WORKSHOP BULLETIN

RE:	PRODUCT
PROPELLER SHAFT	P
	GROUP
	45
	NO.
	3
DATE	
September 1967

Special socket SVO 2779 for flange bolt removal/installation

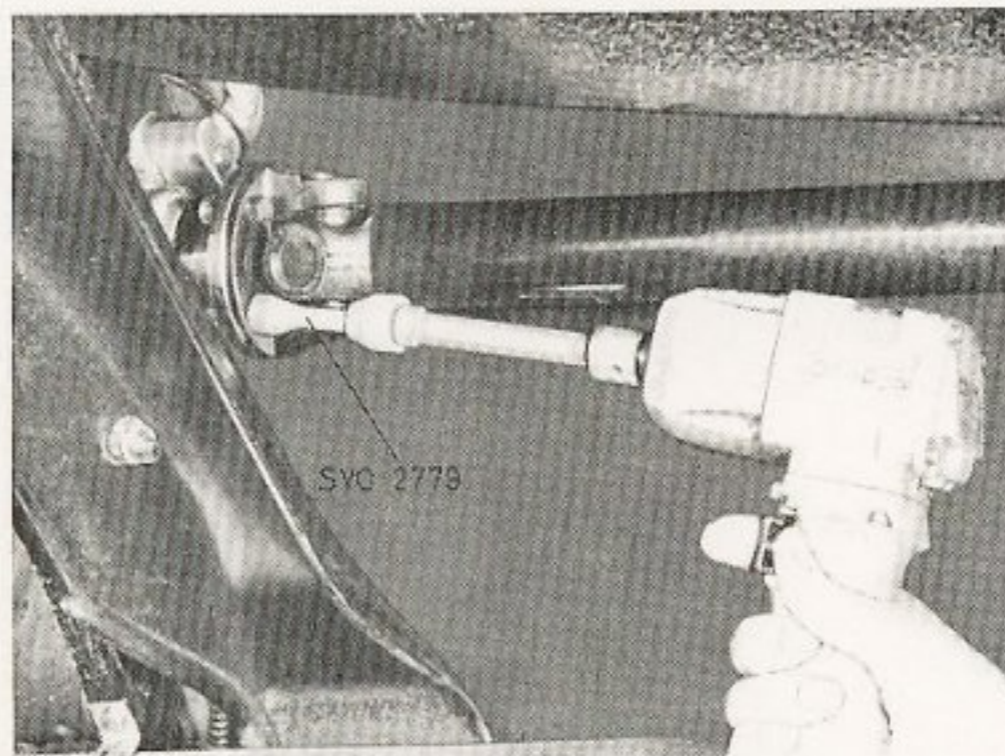
A special socket has been introduced which is connected to an air impact wrench for removal and installation of flange bolts. The across-flats width of the socket is 11 mm (.43") and fits into the air impact wrench with a 1/2" square (extension).
